Subject: Bankshot/Pinball Wizard

Letter No. CEB01-8

Bankshot and Pinball Wizard Vertical Support Replacement

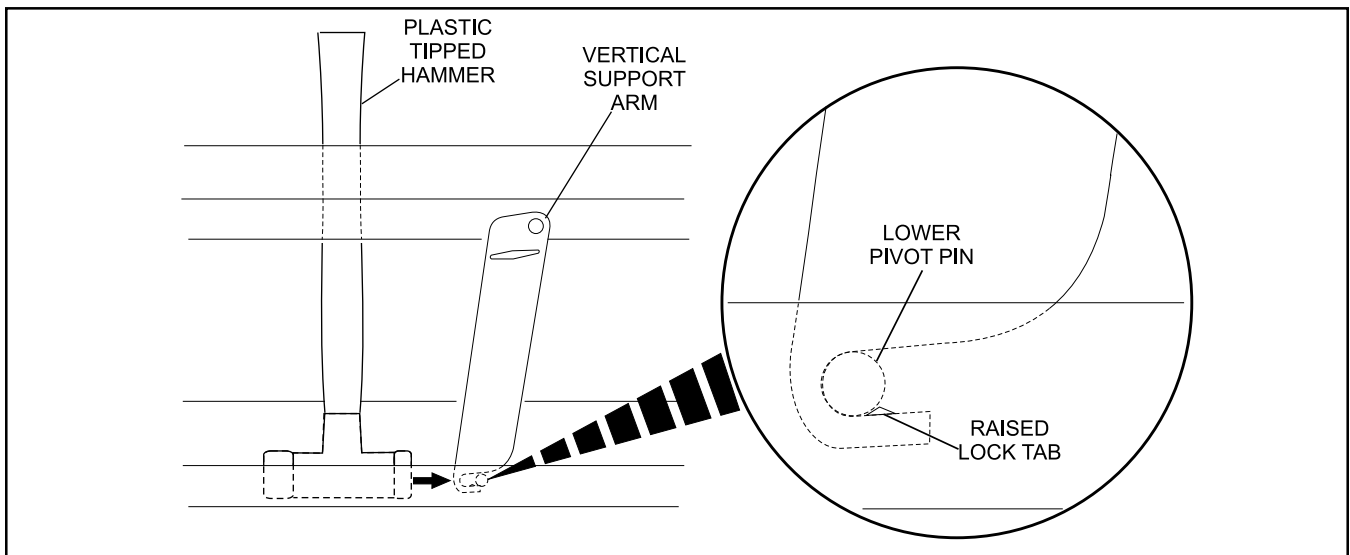
In February 2001, a service bulletin was sent to all Pinball Wizard and Bankshot customers about the availability of replacement pins, clips and vertical support arms. Since that time we have received reports concerning breakage of the hook end of the support arms.

Experience has indicated that this type of breakage is typically associated with a support arm that has not been snapped completely onto the lower pivot pin.

During installation or replacement of any vertical support arms, ensure that the support is installed fully onto the pivot pin by using a plastic tipped hammer to snap the arm firmly into place. Attempting to install the arms by pressing them onto the pivot pin by hand is not sufficient.

If you have recently replaced any support arms, check them to verify that they are installed properly. Failure to do this may result in broken vertical support arms.
